ELECTRO-MOTIVE DIVISION • GENERAL MOTORS CORPORATION

MODERNIZATION RECOMMENDATION

REPLACEMENT OF LUBE OIL STRAINER HOUSING DRAIN VALVES

Fig. 1 - Filter Drain Valve - Exploded View

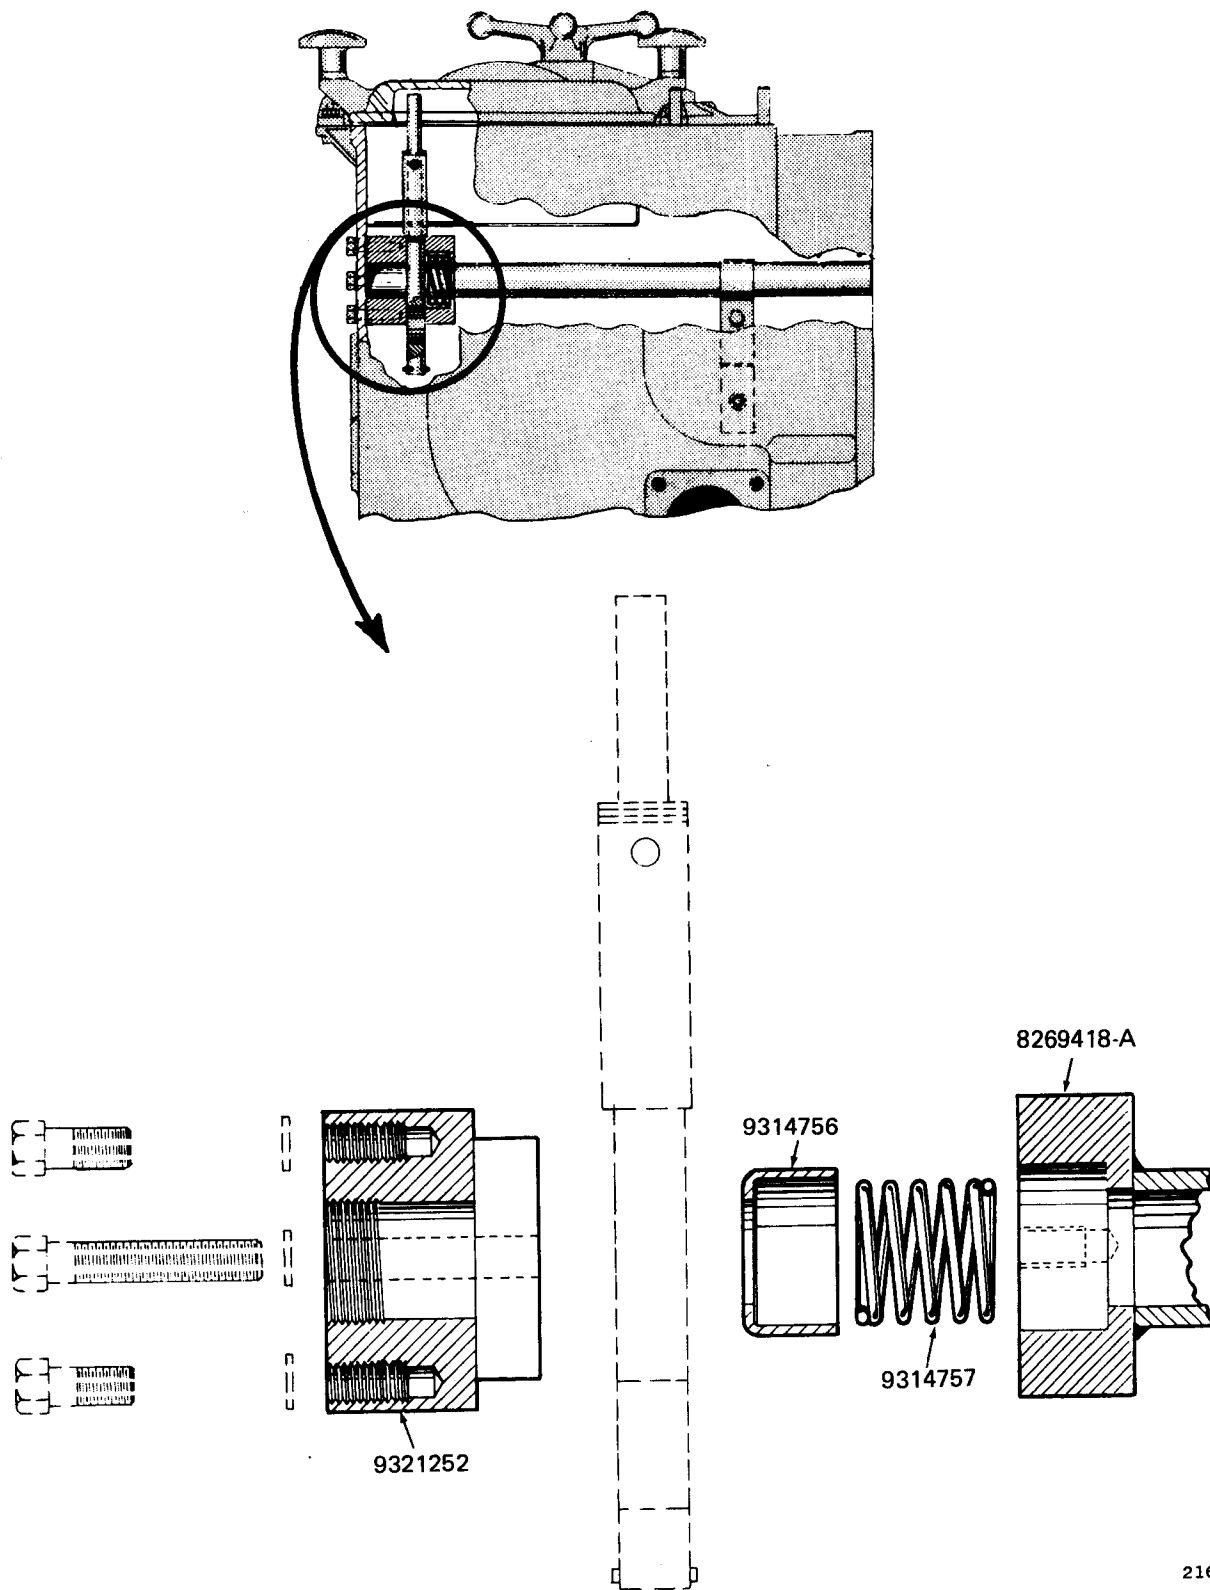
The new filter drain valve design, Fig. 1, spring loads the slider against a seat, with both the slider and seat ground flat to provide a positive seal. The former valve can be modified by interchanging the components listed above and in Fig. 1, with existing components.

Fig. 2 - Strainer Housing Drain Valve - Exploded View

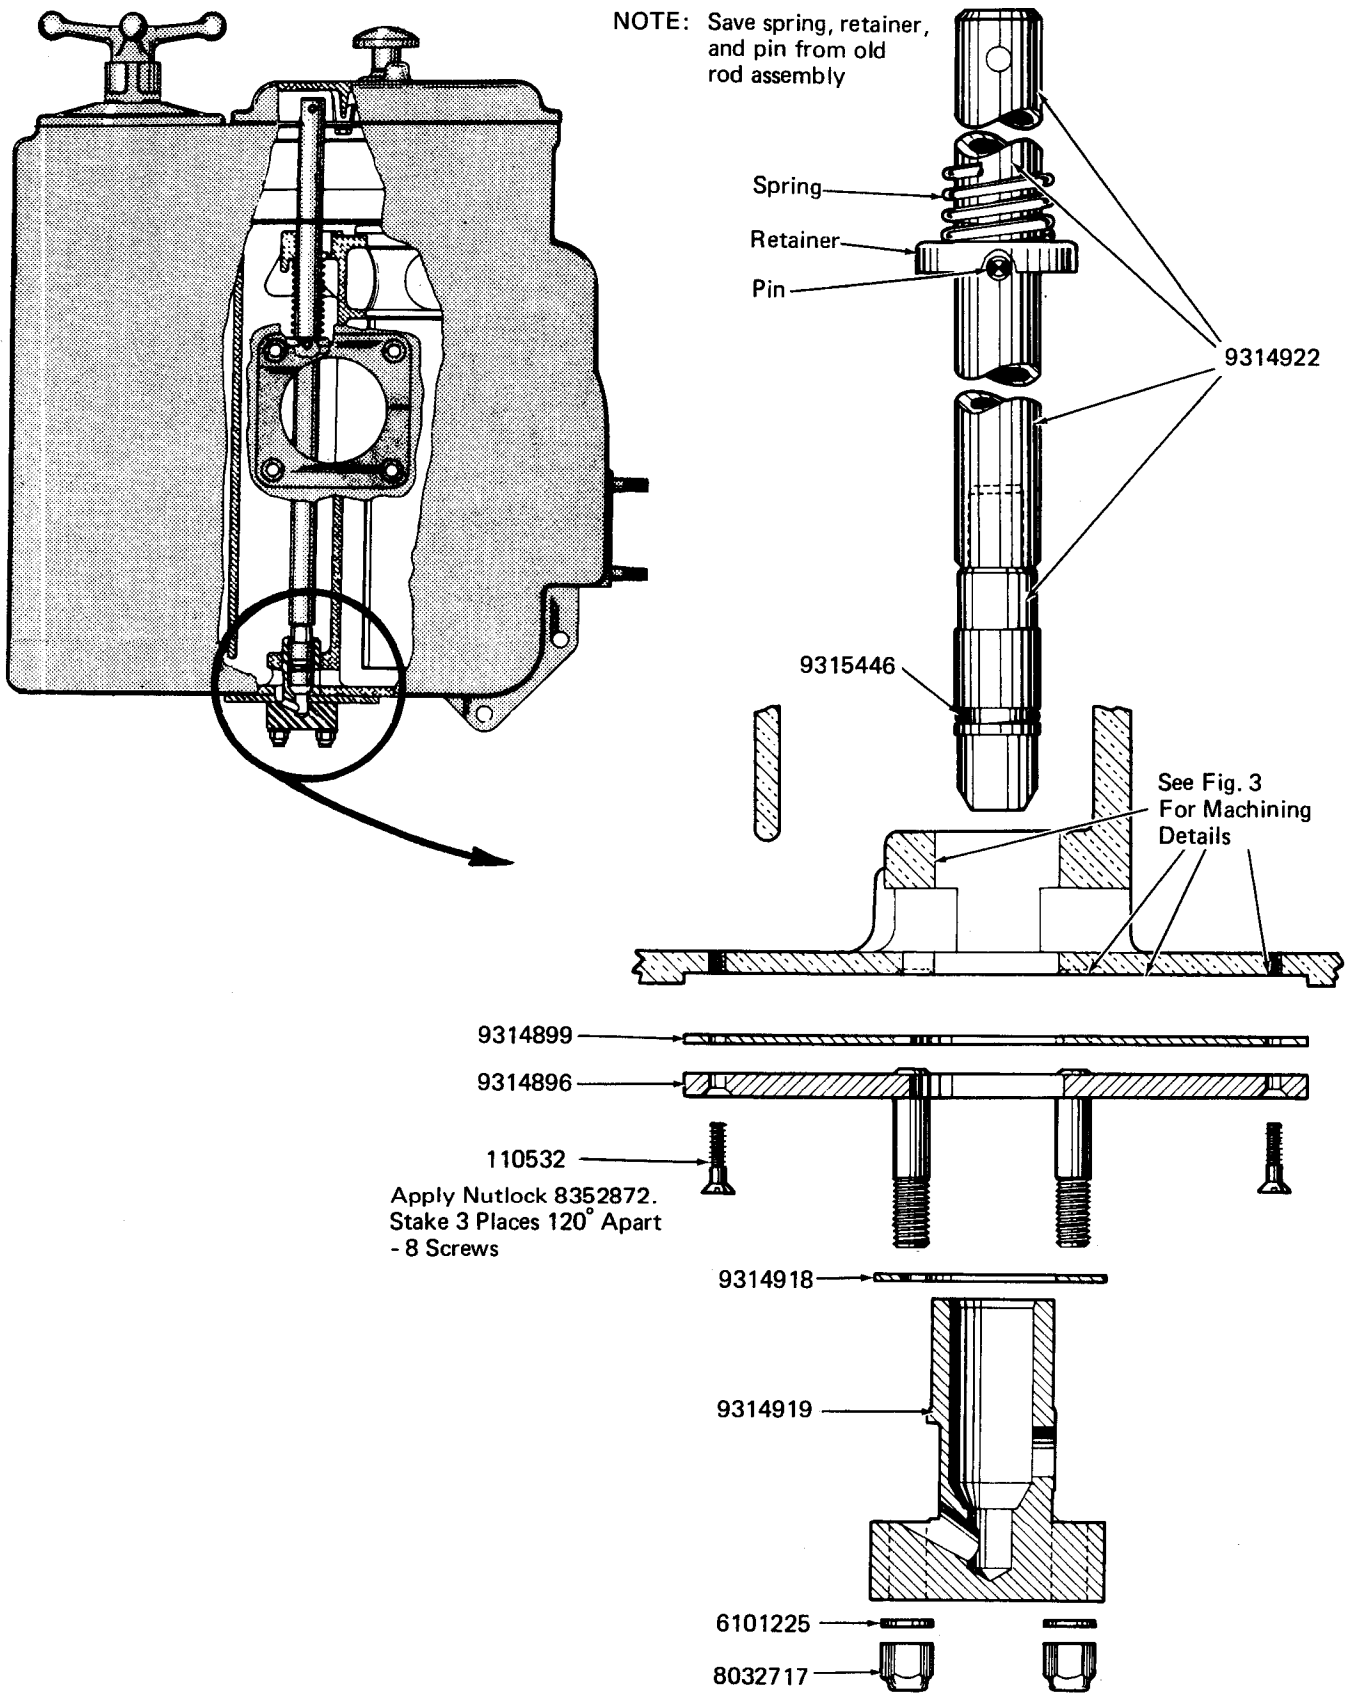
To apply the new design strainer housing drain valve, Fig. 2, four machining operations are required as indicated in Fig. 3.

7. Insert rod assembly 9314922 into appropriate opening in strainer housing. Slide spring and spring retainer from old rod assembly over the end of the rod assembly, then apply O-ring 9315446 to the rod assembly. Position the assembly as indicated in the cutaway of Fig. 2.

Fig. 3 - Strainer Box Alteration - Part 1

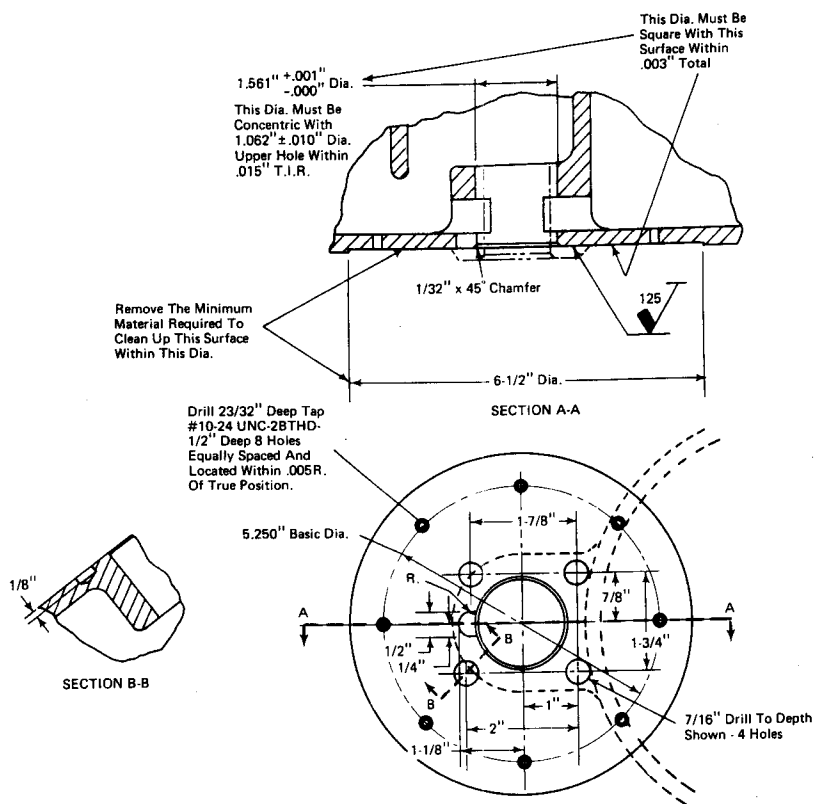
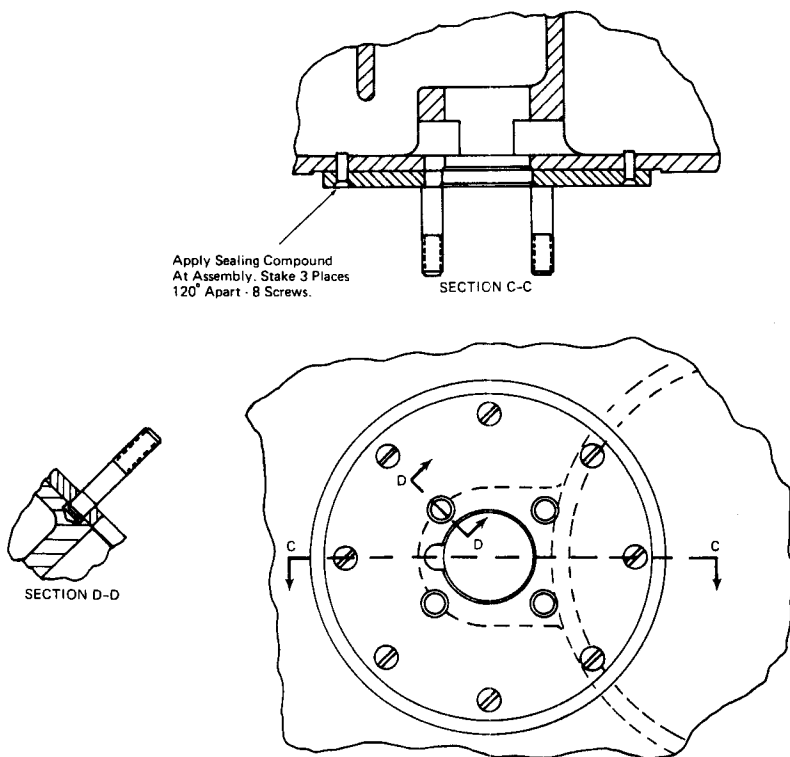
1. The diameter of the bore for the valve seat at the bottom of the housing must be machined to 1.561" +.001" -.000" so that new valve seat 9314919 may be pressed in.

2. The outside bottom surface at 1.561" hole must be faced off to prepare for application of gasket 9314899 and plate assembly 9314896.
3. Eight holes equally spaced must be drilled and tapped No. 10-24 UNC - 2B THD, 1/2" deep.

4. Drill four 7/16" holes 1/8" deep to provide clearance for studs in plate assembly 9314896.
5. After the machining operations are completed, apply plate assembly 9314896, using No. 10-24 screws 110532 and gasket 9314899. Make certain that the drain slots in the gasket and plate line up with the drain slot in the housing. Apply Nutlock 8352872 to the screw threads before assembly. Stake each screw at three places 120° apart after assembly.
